VE No. 11-35

VALUE ENGINEERING CHANGE PROPOSAL
MISSOURI DEPARTMENT OF TRANSPORTATION

Contract ID 110218-503 | Job No. J5P2158

VE #1 - @ LM 0.004 - Begin Project Depth Transition - Rt. 5 (J5P2158)

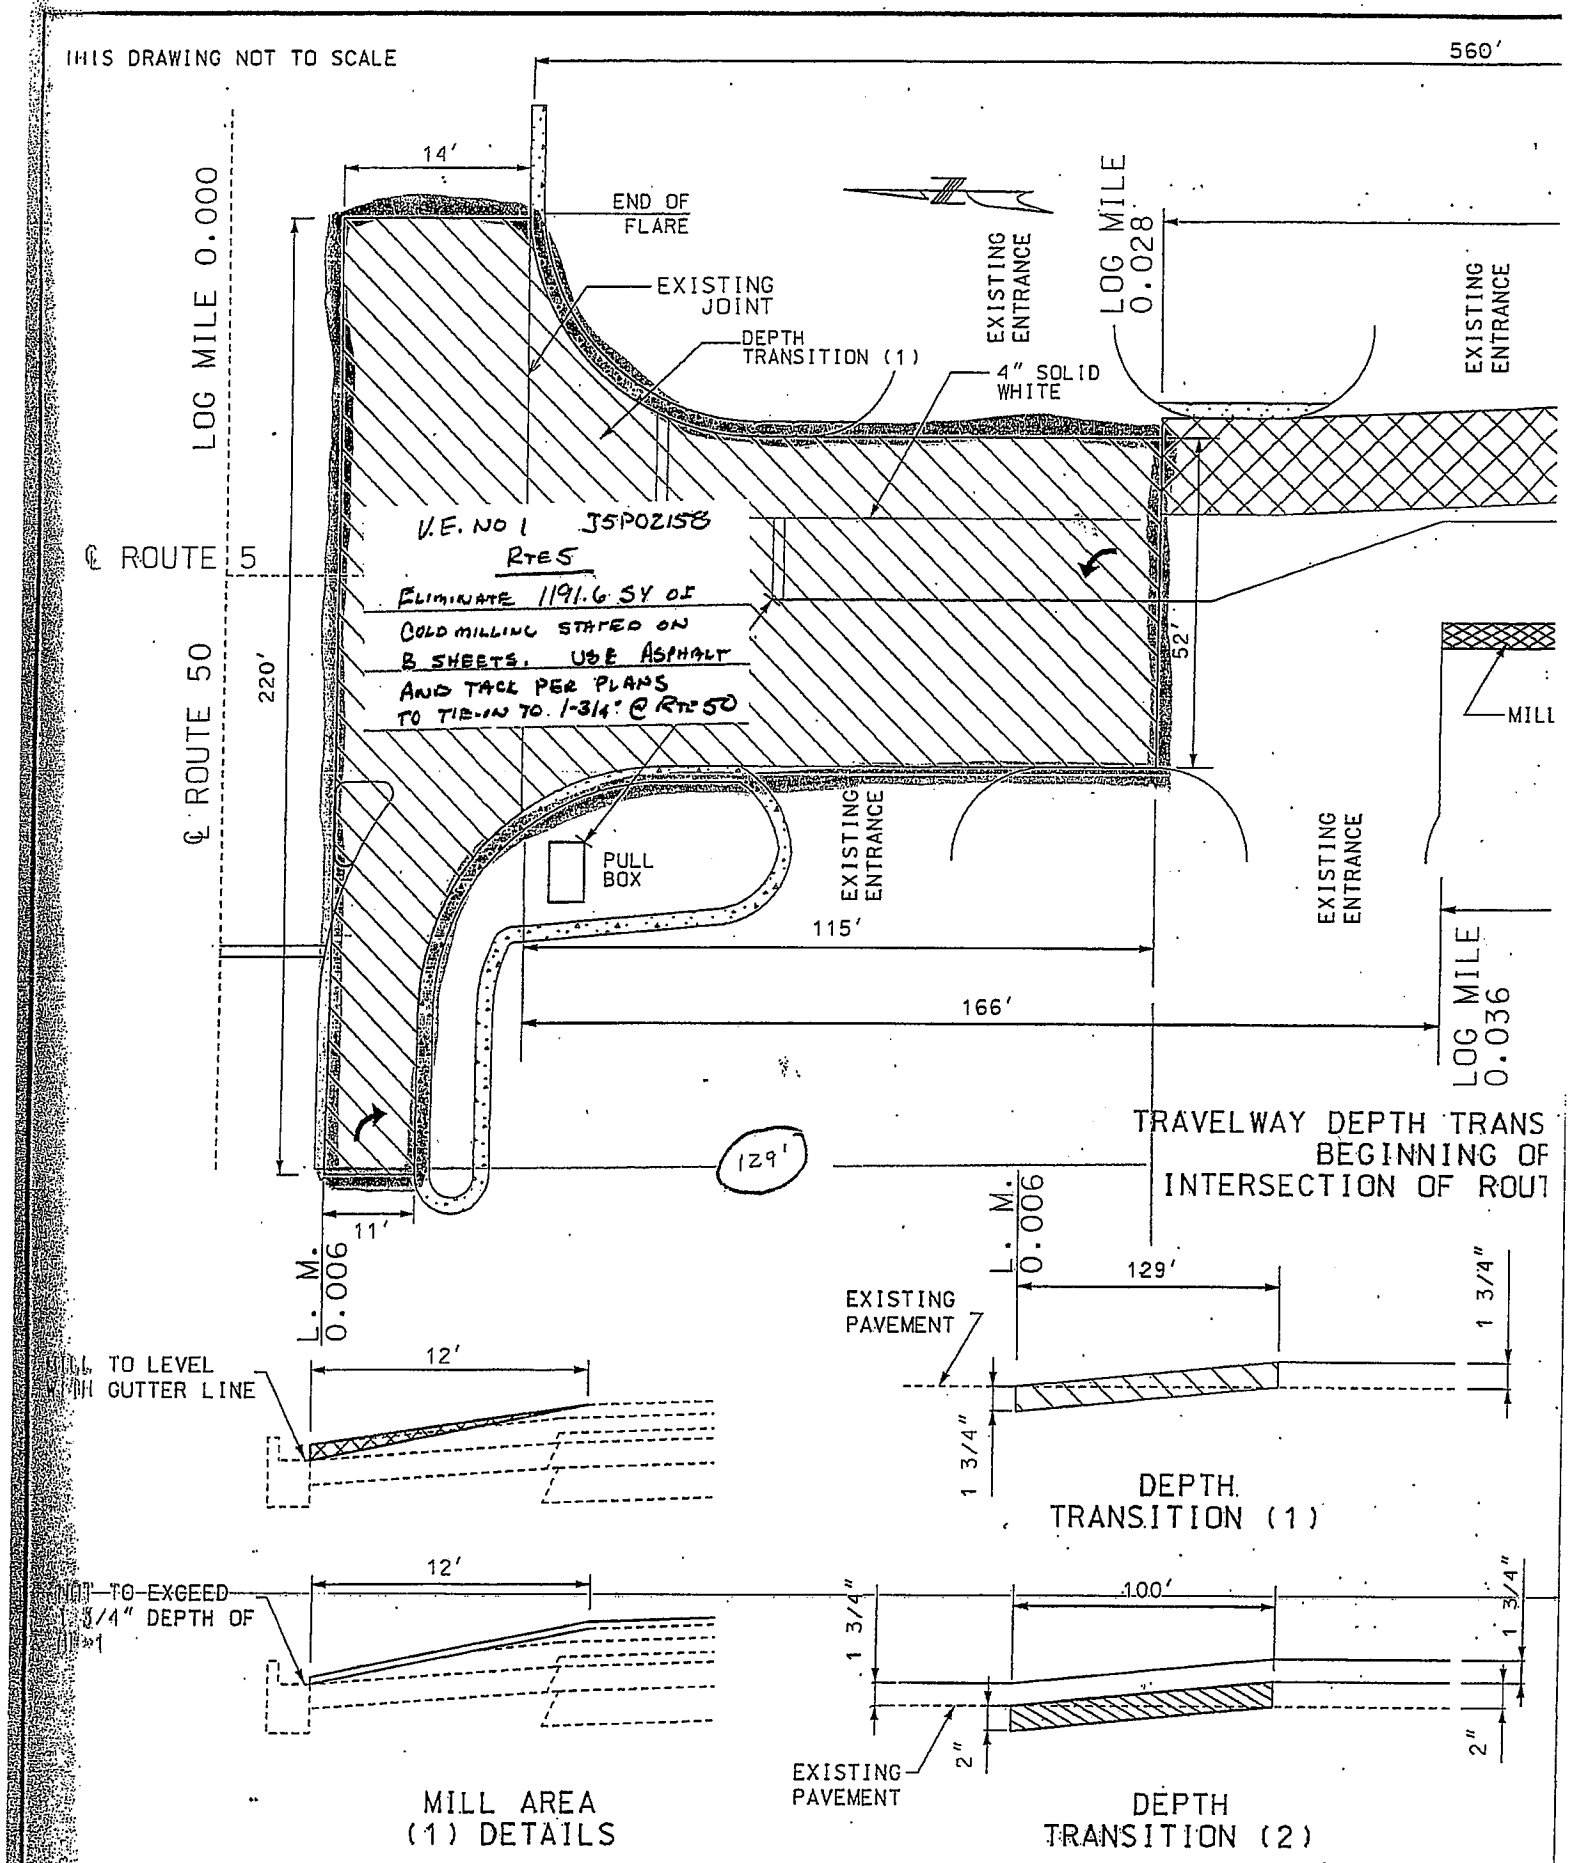
Plans call for 1,191.6 SYDS Modified Coldmilling Depth Transitions at LM 0.004 on J5P2158 for transition into Rte. 50. APAC's operations are to first pave Rte. 50 (J5P0961), leaving the intersections of Rte. 5 elevated 1.75". We will then pave Rte. 5 from the 1.75" elevation left on Rte. 50. Thus eliminating any need for the Modified Coldmilling Depth Transitions, and saving MoDOT $5,243.04. This will expedite the project and lessen the impact on the traveling public. Please see the attached cost savings sheet.

THIS DRAWING NOT TO SCALE
560'
14'
END OF FLARE
EXISTING JOINT
DEPTH TRANSITION (1)
4" SOLID WHITE
EXISTING ENTRANCE
LOG MILE 0.028
EXISTING ENTRANCE
LOG MILE 0.000
℄ ROUTE 5
℄ ROUTE 50
220'
V.E. NO 1 J5P0215B
RTE 5
ELIMINATE 1191.6 SY OF
COLD MILLING STATED ON
B SHEETS. USE ASPHALT
AND TACK PER PLANS
TO TIE-IN TO 1-3/4" @ RTE 50
52'
MILL
PULL BOX
EXISTING ENTRANCE
EXISTING ENTRANCE
115'
166'
LOG MILE 0.036
TRAVELWAY DEPTH TRANS
BEGINNING OF
INTERSECTION OF ROUT
129'
11'
L. M. 0.006
L. M. 0.006
129'
EXISTING PAVEMENT
1 3/4"
1 3/4"
MILL TO LEVEL WITH GUTTER LINE
12'
DEPTH TRANSITION (1)
NOT TO EXCEED 1 3/4" DEPTH OF MILL
12'
1 3/4"
100'
1 3/4"
2"
2"
EXISTING PAVEMENT
MILL AREA (1) DETAILS
DEPTH TRANSITION (2)

Comments: Due to Job. No. J5P2158 & Job No. J5P0961 adjoining at the intersection of Rte 5 & Rte 50 in Tipton, it is unnecessary to perform modified cold mill depth transitions at this location. Therefore, this 50% VE proposal is acceptable.

Agree with comments above. Proposal makes sense and is the right thing to do. given the circumstances, and APAC's willingness to coordinate operations among the projects.
